S.S. "TSINAN"

310' x 45' x 24:75' to upper deck
32:00' to bridge deck.

A letter and cable have been received from the Hong Kong Surveyors (October 17 and 30 1951) stating that the new Owners of this ship, which has load lines assigned by the Society, contemplate converting her to oil burning, and desire to know the Society's requirements for classification.

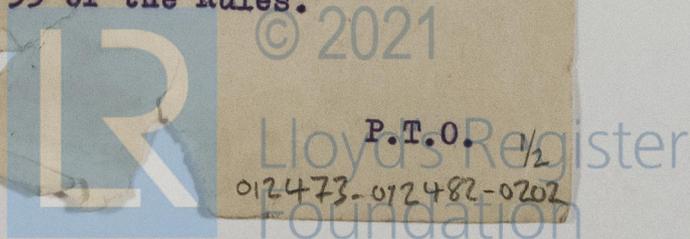
The plans referred to above have been examined on the basis of the Lloyd's Rules then in force, and are found with slight exceptions (beams on upper deck on alternate frames) to be such as could be recommended to the Committee for class 100A.

- (1) Half beams are fitted at frames 69, 71, 73 & 75 below the upper deck p & s.
- (2) A short girder is fitted on the underside of the upper deck between frames 68 and 79 in line with the steel bulkheads above at about 13'-6" from centreline of ship p & s. (see attached sketch).
- (3) The ship is generally examined in drydock, the steering gear opened up for survey and the anchors and cables ranged.
- (4) Particulars of the drillings taken at the loadline renewal survey are forwarded to the office and found in order.
